Geochemical Consulting Services, LLC

July 28, 2008

I have reviewed documents associated with the Renewal of the Source Material License (No. SUA-1534) for Crow Butte, Nebraska and have found the applicant has not provided sufficient data to demonstrate proper development of (1) baseline water quality in the aquifer exemption zone and (2) excursion limits at monitoring wells.

United States Nuclear Regulatory Commission Official Hearing Exhibit	
In the Matter of: CROW BUTTE RESOURCES, INC. (License Renewal for the In Situ Leach Facility, Crawford, Nebraska)	
ASLBP #: 08-867-02-OLA-BD01 Docket #: 04008943 Exhibit #: INT-002-00-BD01 Admitted: 8/18/2015 Rejected: Other:	Identified: 8/18/2015 Withdrawn: Stricken:

Figure 1. Chart of aquifer exempt zone (i.e., zone surrounded by monitoring wells) and locations for baseline wells established with valid statistical methods.

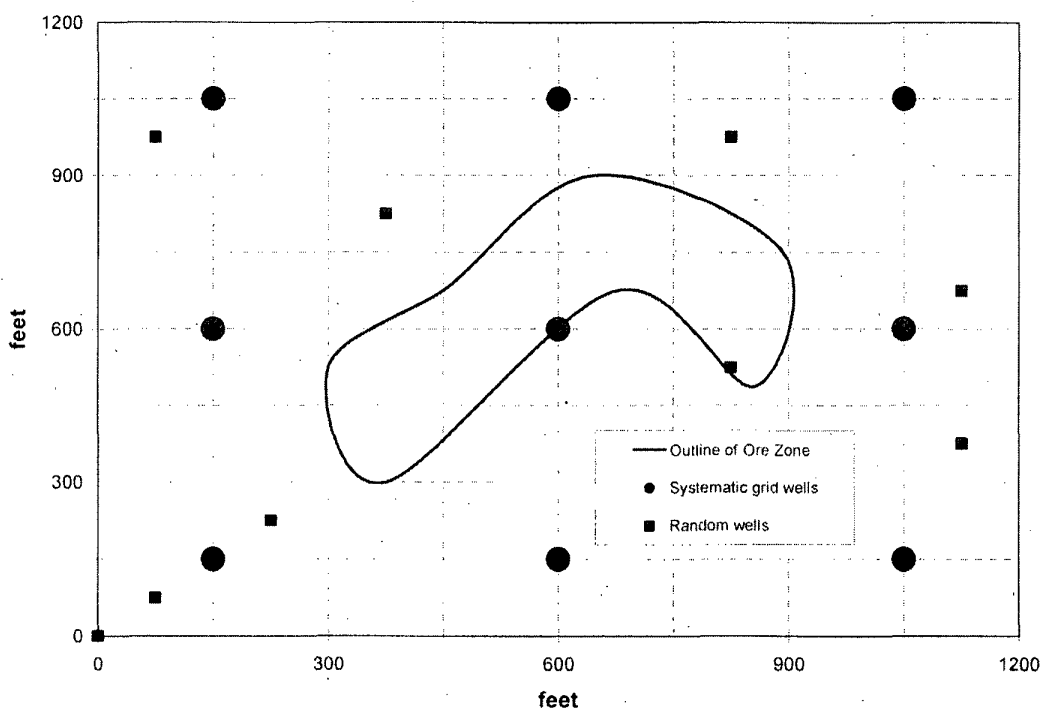
Alternatively, we may elect to locate wells on the grid using a random number generator. In general, less wells are required if they are located randomly, and this is shown on Figure 1 as two random locations per quadrant. Free modeling software, developed by the Pacific Northwest National Laboratory for the Department of Energy (PNNL 2007), allows a large number of scenarios to be evaluated to determine the optimum data quality objectives and sampling approach for the stakeholders.

Assume nine samples were taken from the nine locations on Figure 1 and analyzed for radium-226. A valid statistical sampling of the exempt aquifer zone collects more

Figure 2. Cross section of an aquifer (20 to 90 feet) showing improper (Well 1) and proper (Well 2) sampling intervals to obtain a representative sample.

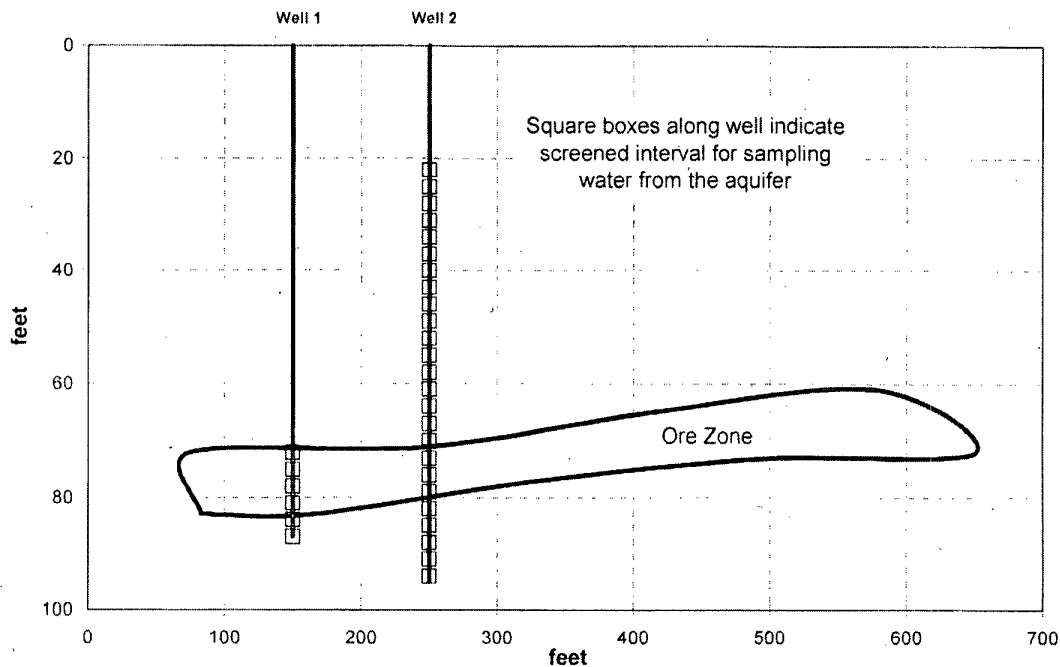
The well logs provided indicate the Chadron is approximately 50 to 80 feet thick through most of the mining area (Figures 2.6-4 through 2.6-11). The sampling interval for the baseline wells is 20 feet (Table 2.9-3), which does not represent the entire thickness of the aquifer. Figure 2 shows that a water sample obtained from Well 1, screened only in the ore zone, returns a biased sample that does not represent the water quality of the column of water at the given location. Well 2 (Figure 2) indicates the correct method for sampling the water, which requires that the entire thickness of the aquifer be screened to obtain a representative sample.

Figure 3. Probability plot indicating that all data do not lie near or on a straight line, which rules out a normal or log normal distribution.

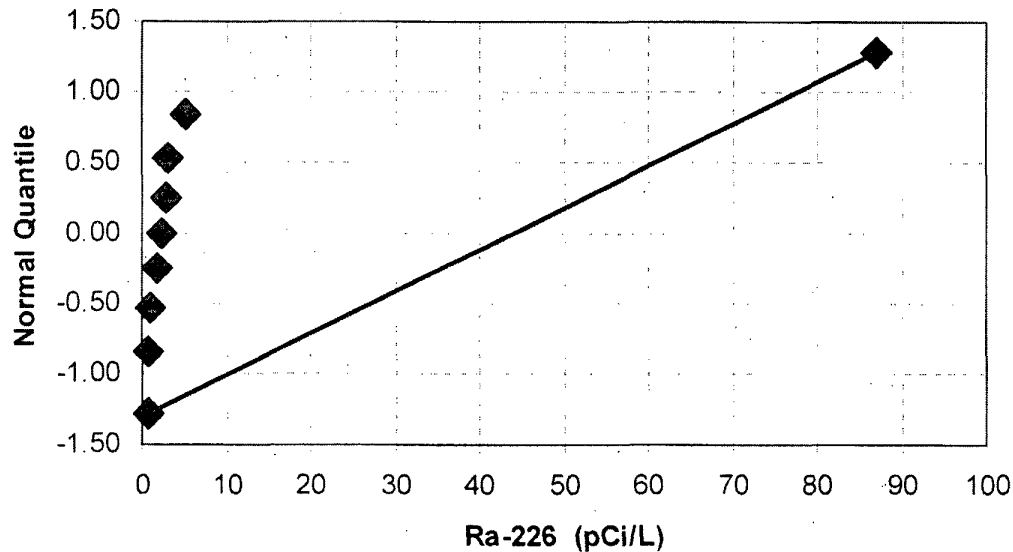
A probability plot of the data (Figure 3) and the results of the Shapiro-Wilk test confirm this. The normal-quantile values must fall on a straight line or the Shapiro-Wilk probability values must exceed 0.05 (at the 95 percent confidence level) for a normal or log normal distribution to be declared, which is clearly not the case. Therefore, the median, and not the mean, must be used to represent the central tendency of the data. Note that inappropriate use of the mean results in a high bias on the estimate of the baseline value for radium-226, which improperly elevates restoration clean-up levels and lowers the costs associated with the number of pore volumes needed to exchange to meet the clean-up levels.

Figure 4. Proper use of a control chart to determine lixiviant excursions.

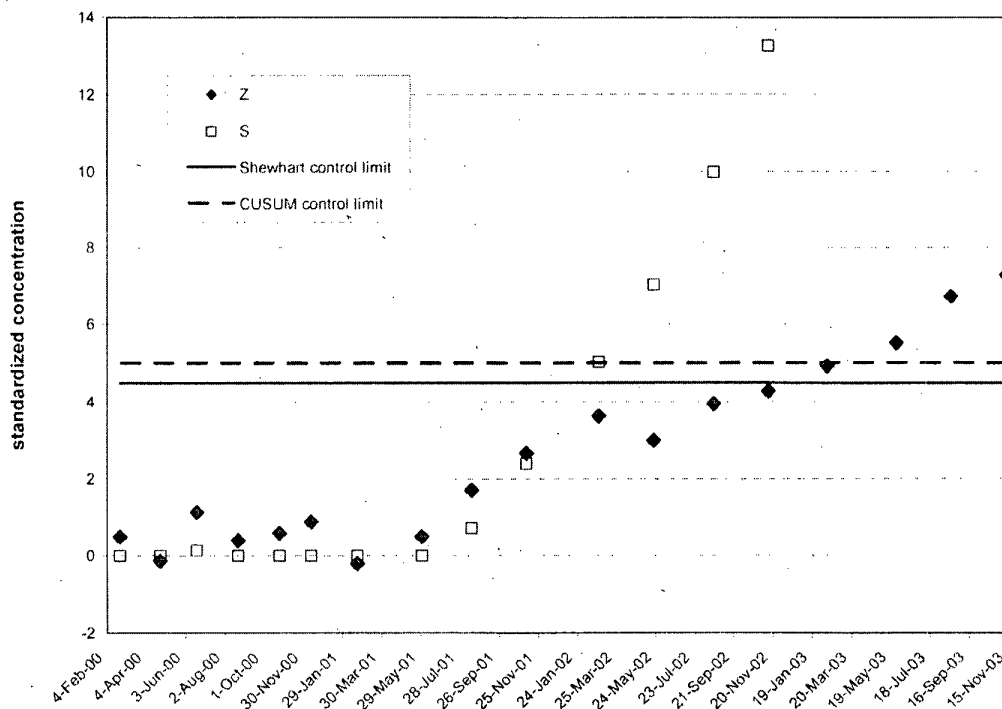
Figure 4 illustrates the importance of using the SCL and CUSUM for monitoring lixiviant excursion. The SCL (Z) and CUSUM (C) are plotted for an excursion parameter, a gradual increase in contamination exceeds the CUSUM limit in February of 2002, while the SCL limit is not exceeded until January of 2003. The SCL limit is similar to the CBR's use of 5 standard deviations above the mean for any one sampling event, although EPA recommends 4.5 standard deviations for any one sampling event. Using only the SCL limit allows contamination to migrate beyond the monitoring well for nearly a year before an excursion is declared. Therefore, if the CUSUM is not used with the SCL limit a gradual increase in contamination will not be detected and migration of diluted lixiviant will pass the monitoring well without corrective action.
